My wife and I previously submitted an objection to planning application DM/25/1495 on the 27th June 2025. However, new information has come to our attention pertinent to this application by Cellnex. We wish to submit additional new objections to this application:

The stated objective of the development “*is to provide 4G connectivity to passengers using the Brighton Main Line (BML).*”

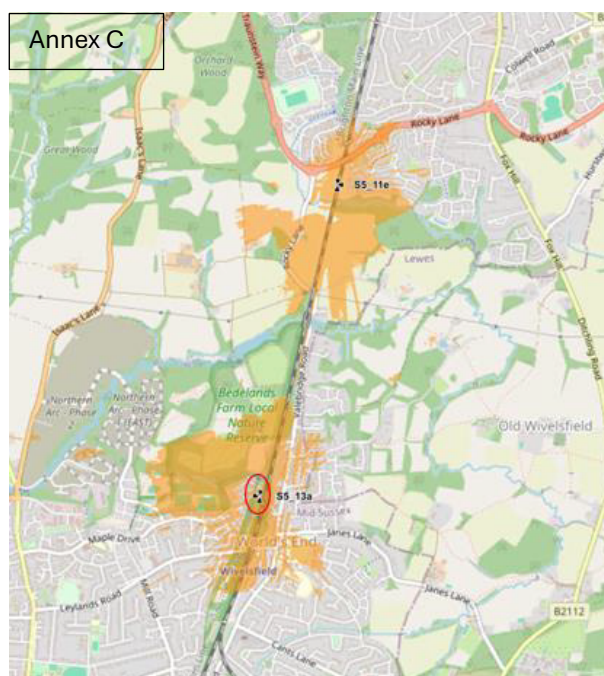
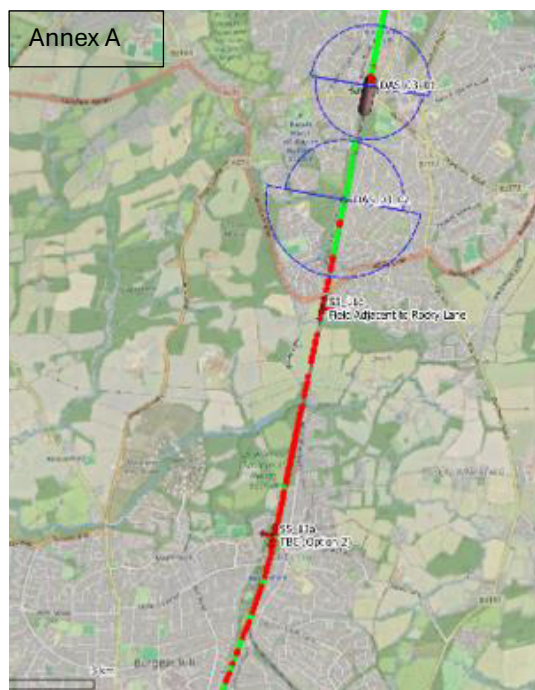
Cellnex gives the reason for this development as “*The principal objective of the Brighton Main Line project is to provide seamless fourthgeneration (4G) connectivity to passengers using the railway line.*” To support the need for the mast at the proposed site just off Rocky Lane, their Technical Support Statement shows the currently available network cover in Annex A. The relevant section of this is reproduced on the next page. The green dots denote sufficient existing coverage and the red dots insufficient existing coverage.

As I mentioned in my earlier objection this clearly shows a gap in the network cover provided between the two proposed developments, which is counter to the stated purpose of the development – to provide “seamless 4G connectivity”. However, I also pointed out that whenever I have travelled this section of track, I have not experienced any connectivity problems, and I am unaware of any other travellers experiencing connectivity problems. I also pointed out that all the major network providers claim to have excellent signal coverage of this area. In view of this I contacted several companies that provide independent verification of network performance for the industry to understand why there is a discrepancy between the data provided by Cellnex and the experience of passengers travelling on the BML and the excellent coverage claims of network providers. Below is the network coverage map provided by one of the open-source independent network performance assessors (Figure 1) for transport routes in the Haywards Heath/Burgess Hill area. This company is called Network

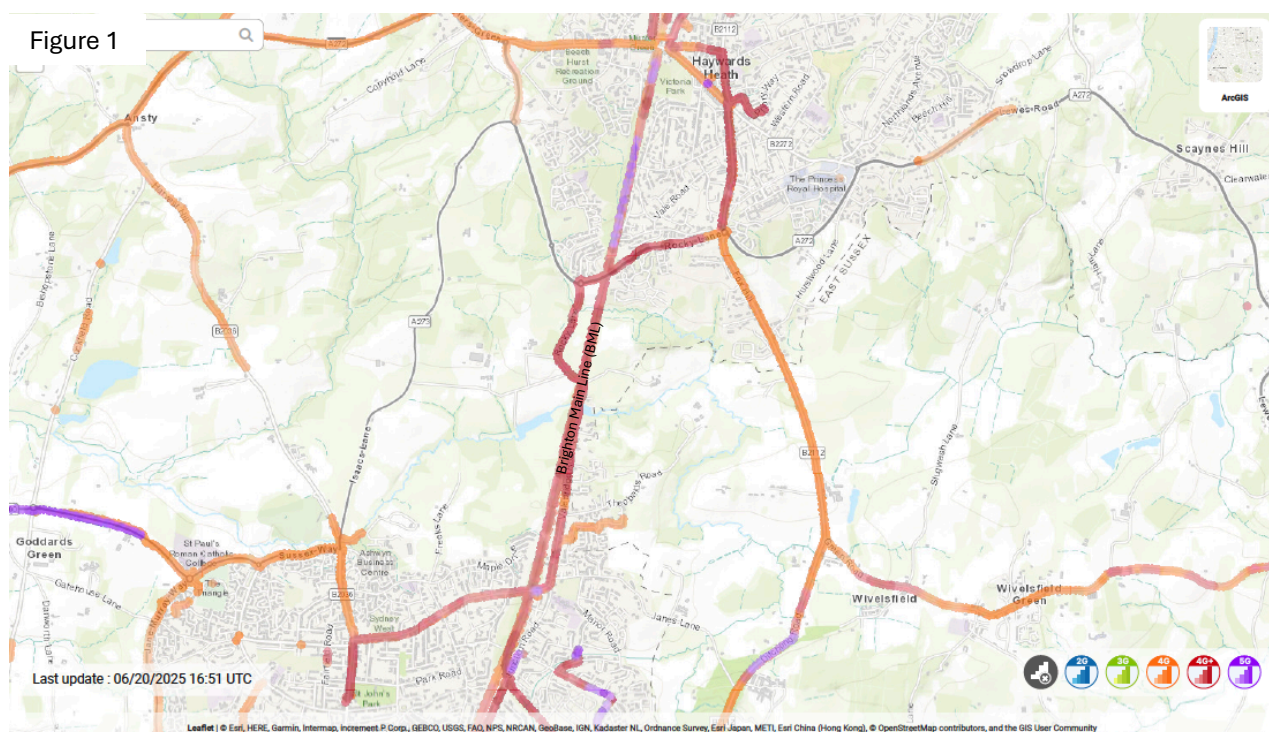
The map shows 4G cover strength in shades of orange, 4G+ in shades of red and 5G in shades of purple. You will note that the entirety of the BML track shown in the Cellnex technical document as having insufficient cover, is shown on this map to have excellent 4G and 4G+ cover. 4G+ (also known as LTE-Advanced or 4.5G) offers faster data speeds than standard 4G. While 4G typically offers speeds up to 100 Mbps, 4G+ can reach speeds of 300 Mbps or higher. **This shows that there is already seamless 4G & 4G+ connectivity for passengers using this stretch of the BML.**

Figure 2

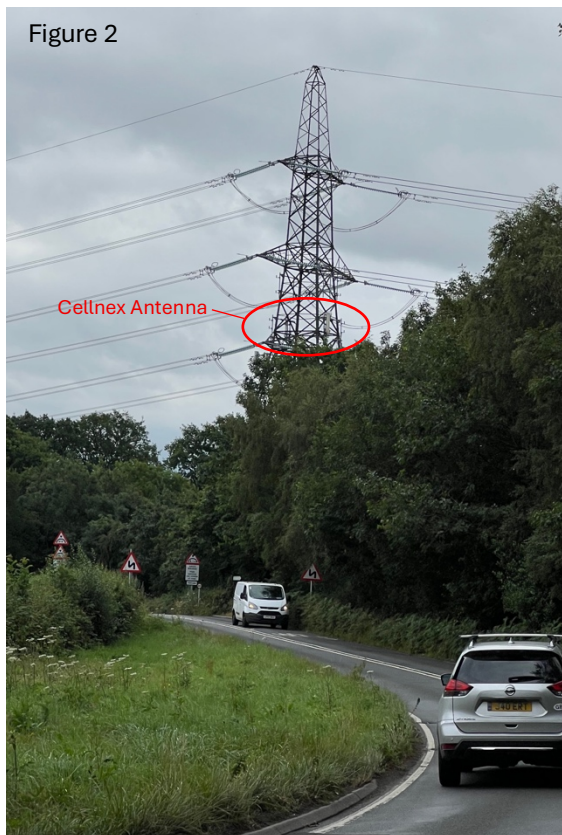
The pylon 4VM12 that they refer to is a 50m tall electricity pylon located at grid reference 532344, 121522 very close to where Rocky Lane passes through the low bridge under the BML (see Figure 2). It is owned and operated by National Grid (NG) and Cellnex have a licence to install and operate telecommunications infrastructure on existing NG electricity pylons like this. Notably, this location is at the center of the strongest 4G/4G+ cover shown on the network cover map above (Figure 1). Confirming that this is the source of signal to this stretch of track, and that this location can provide better and more extensive network cover to the BML than the proposed new development at DM/25/1495. Indeed, unlike the DM25/1495 proposal, this location already provides signal that links the existing signal in Haywards Heath to the existing signal in Burgess Hill providing 'seamless 4G cover to the BML' without the need for any new masts or other structure.
